# Access Compliance Report

### (Curb Ramps)

Intersection ID: 25480	Main Street: HATTON_CROSS_DR	Cross Street: WEATHERSTONE_CR	Location: SE
ADA ID: 47B4F50B3E0E	Ramp Type: BlendTrans2	Initial Pass/Fail: Pass	Overall Compliance: No
			Severity Score: 10.25

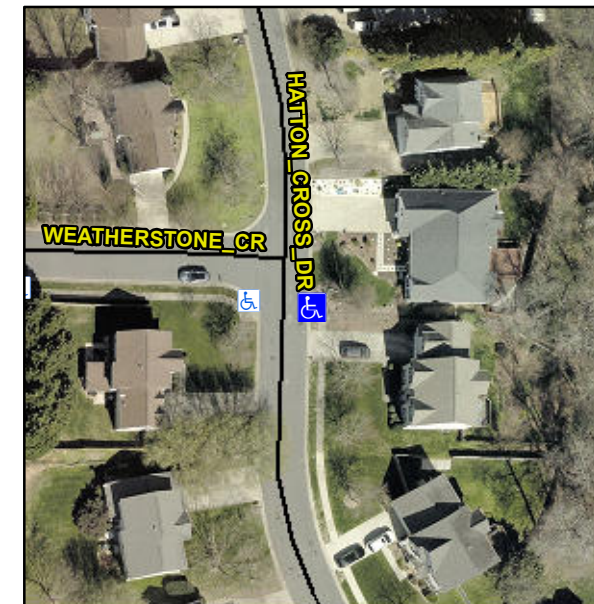
**CURB LIP 2.0**

**Not Found, R304.5.3, R305**

Compliance	Description	Data	Compliance	Description	Data
N/A	Ramp Length (in)	95.5	Yes	BlendTrans Slope (%)	1.8
Yes	Ramp Width (in)	59.5	No	BlendTrans XSlope (%)	3.6
N/A	Flare Type LT	None	N/A	Flare Type RT	None
N/A	Flare Slope LT (%)	N/A	N/A	Flare Slope RT (%)	N/A
N/A	Flare Traversable LT?	N/A	N/A	Flare Traversable RT?	N/A
N/A	Landing Length (in)	N/A	No	DWS Provided?	No
N/A	Landing Width (in)	N/A	N/A	DWS Contrast?	No
N/A	Landing Slope (%)	N/A	N/A	DWS Length (in)	N/A
N/A	Landing X Slope (%)	N/A	N/A	DWS Full Width?	No
N/A	Landing Curb? (Y/N)	No	N/A	DWS Offset (in)	N/A
N/A	Shared Landing?	No			
Yes	Gutter Ponding?	No	Yes	Gutter Slope (%)	3.0
Yes	Gutter Lip Ht (in)	0.0	Yes	Gutter X Slope (%)	2.2
N/A	Painted X Walk1?	No	N/A	Painted X Walk2?	N/A
	X Walk 1 Direction	To W		X Walk 2 Direction	N/A
	X Walk 1 Width (in)	N/A		X Walk 2 Width (in)	N/A
	X Walk 1 Slope (%)	7.6		X Walk 2 Slope (%)	N/A
	X Walk 1 X Slope (%)	3.0		X Walk 2 X Slope (%)	N/A

N/A	Ramp inside XWalk1?	N/A	N/A	Ramp inside XWalk2?	N/A
	Road Slope (%)	3.0		Clear Space?	Yes
	Road X Slope (%)	7.6	N/A	Clear Space to XWalk (in)	N/A
Yes	Any Obstructions?	No	Yes	Storm Grate/Utility Hazard?	No
	Obstruction Type			Storm Grate/Utility Type	
		N/A			N/A
			Yes	Surface Condition? (G/P)	Good
			No	Curb Slope (%)	31.5

**Remove & Replace Curb Ramp With Two New Directional Ramps or Equivalent.**
